STATE OF MAINE
DEPARTMENT OF TRANSPORTATION
16 STATE HOUSE STATION
AUGUSTA, MAINE 04333-0016

July 1, 2025
Subject: Bridge Replacement
WIN: 025161.00
Location: **Cumberland**
Amendment No. 2

SHEET NUMBER	2	OF 88	TUTTLE ROAD BRIDGE										PROJ. MANAGER	Cerdia Dostie	BY	DATE	STATE OF MAINE DEPARTMENT OF TRANSPORTATION					
			INTERSTATE 295, RTE US 1 & MCRR										DESIGN-DETAILED	CT	CT	03/2025						
			CUMBERLAND CUMBERLAND COUNTY										CHECKED-REVIEWED	RF	RF	03/2025						
													DESIGN2-DETAILED2									
													DESIGN3-DETAILED3									
ESTIMATED QUANTITIES													REVISIONS 1	UPDATED QUANTITIES			P.E. NUMBER	2516100				
													REVISIONS 2									
													REVISIONS 3									
													REVISIONS 4									
													FIELD CHANGES									
																				BRIDGE NO. 5801	WIN 25161.00	BRIDGE PLANS

STATE OF MAINE DEPARTMENT OF TRANSPORTATION	2516100		WIN 25161.00		BRIDGE NO. 6601		BRIDGE PLANS	
	TUTTLE ROAD BRIDGE		INTERSTATE 295, RTE US 1 & MCRR		CUMBERLAND COUNTY		PIER FOOTING & NOTES	
	SHEET NUMBER		58		OF 88

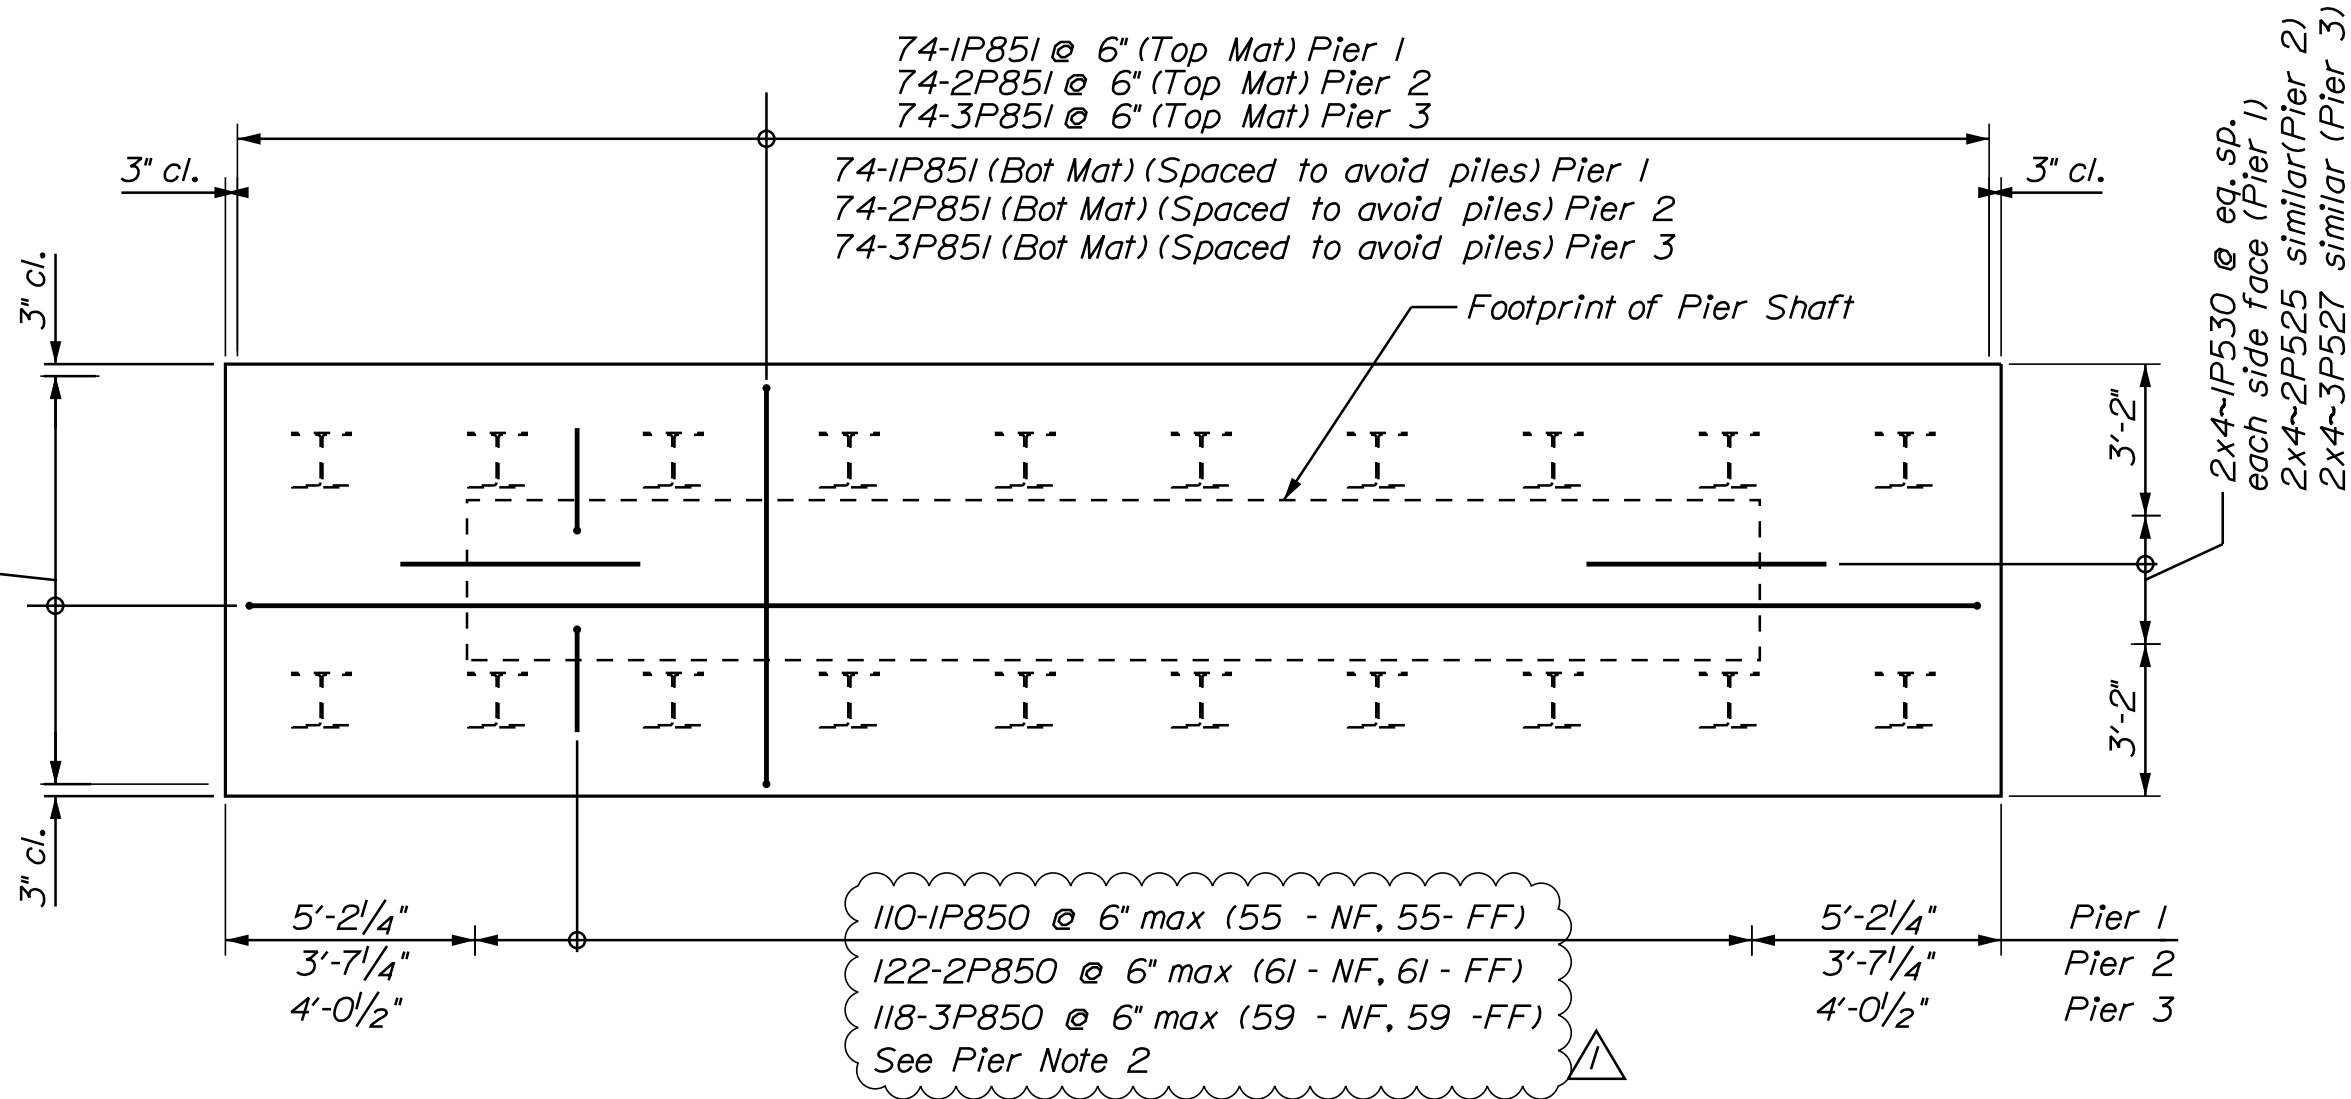
REMOVE Sheet Number 2 of 88, ESTIMATED QUANTITIES dated 5/25/2025 and **REPLACE** with the attached Sheet Number 2 of 88, ESTIMATED QUANTITIES dated 6/30/2025.

Question: Would the Department consider changing the method of measurement for reinforcing steel to be by the pound rather than lump sum? If not, how will reinforcing steel changes be handled? We have never seen reinforcing steel be paid as lump sum on past projects or current projects out to bid.

Question: How was the common borrow calculated? The quantity seems extremely high.

Response: The reinforcing items have been changed to pound quantities. See updated Sheet 2 and Proposal Schedule of Items.

Response: Please see the updated quantity on Sheet 2.

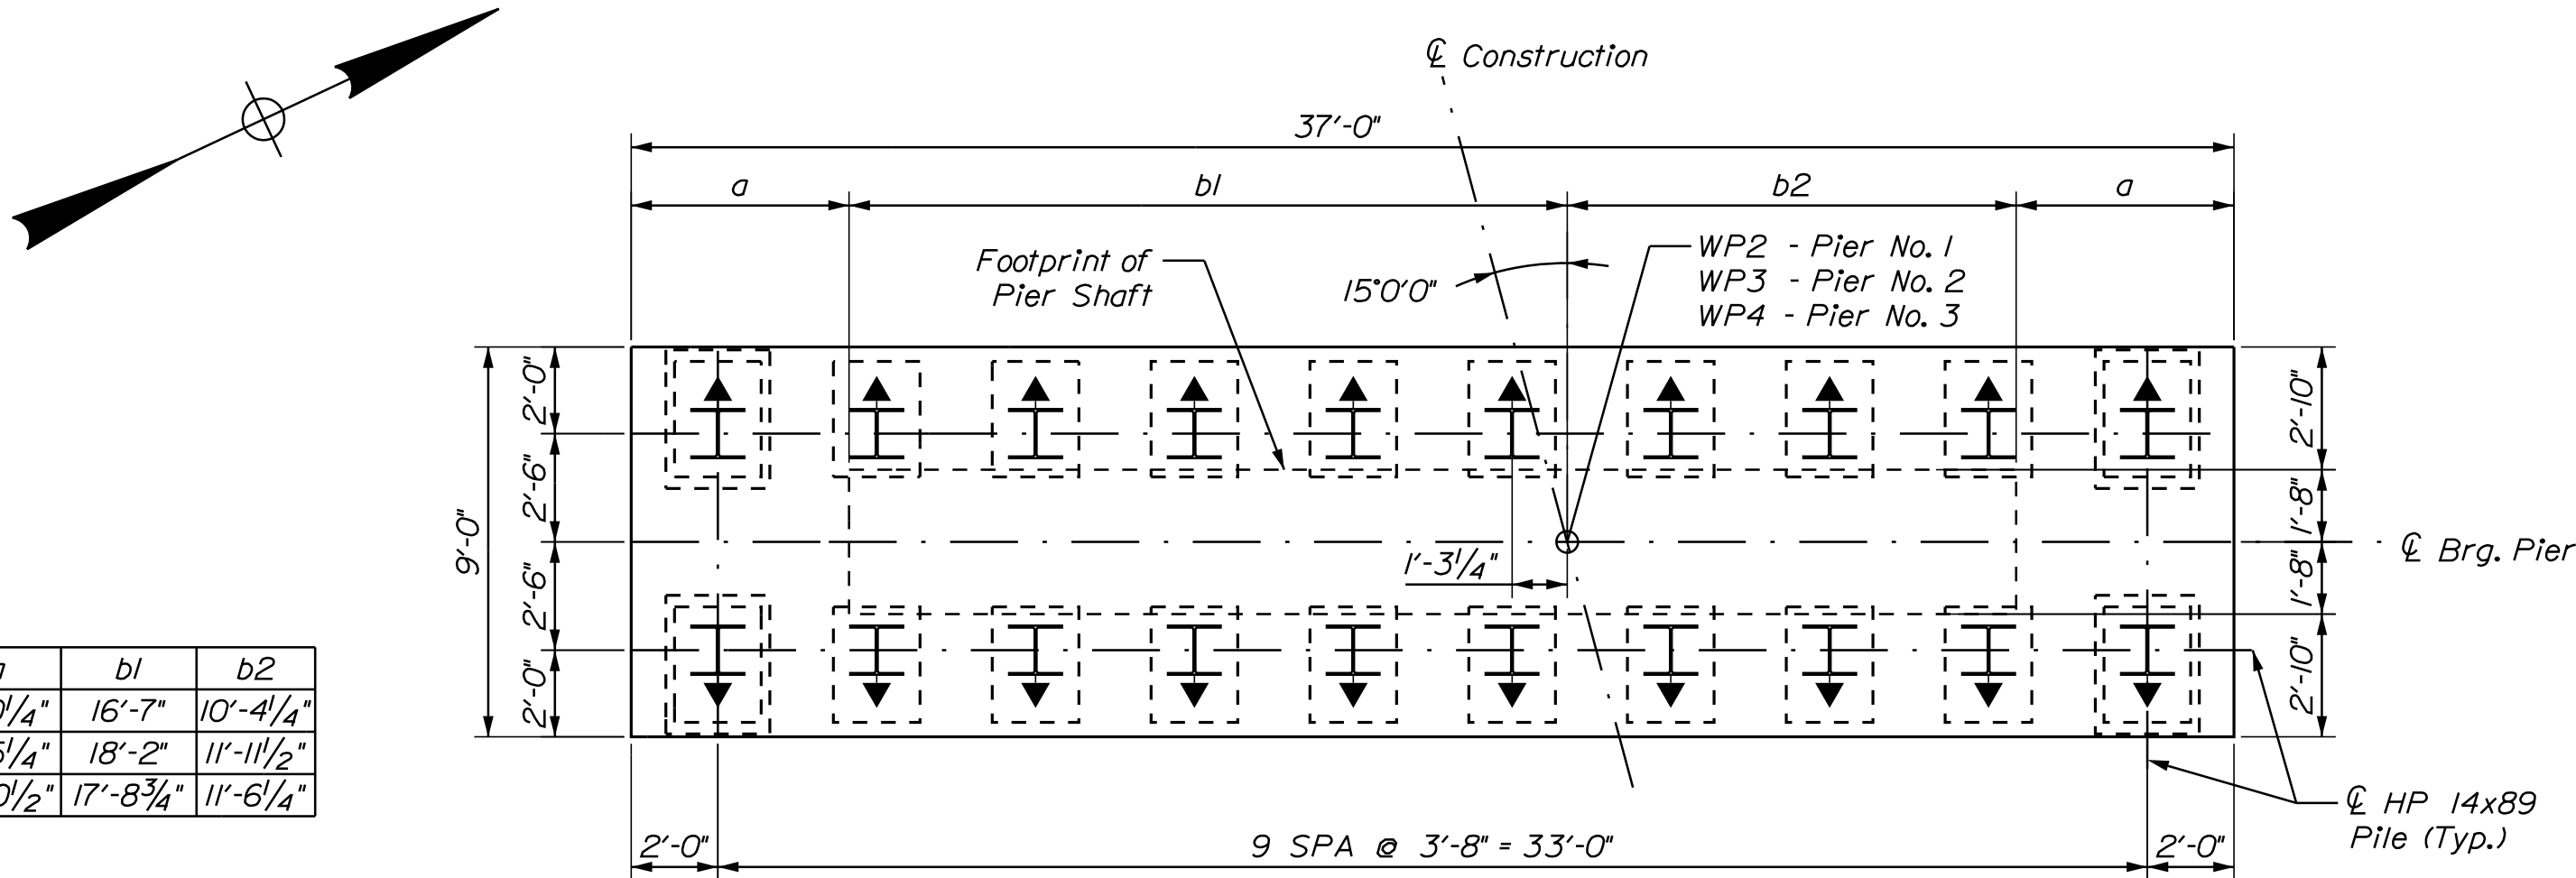
REMOVE Sheet Number 58 of 88, PIER FOOTING & NOTES dated 5/25/2025 and **REPLACE** with the attached Sheet Number 58 of 88, PIER FOOTING & NOTES dated 6/26/2025.

Question: On sheet 58 the footing rebar marks 1P850, 2P850 & 3P850 show quantities which are more than that shown on the Pier elevations on sheets 60, 61 & 62 as well as the bar lists on sheets 84 & 85. What are the correct quantities?

Response: The quantities on Sheets 84 and 85 are correct. Sheets 60, 61, and 62 show the quantity of one face. See the revised Sheet 58 above.
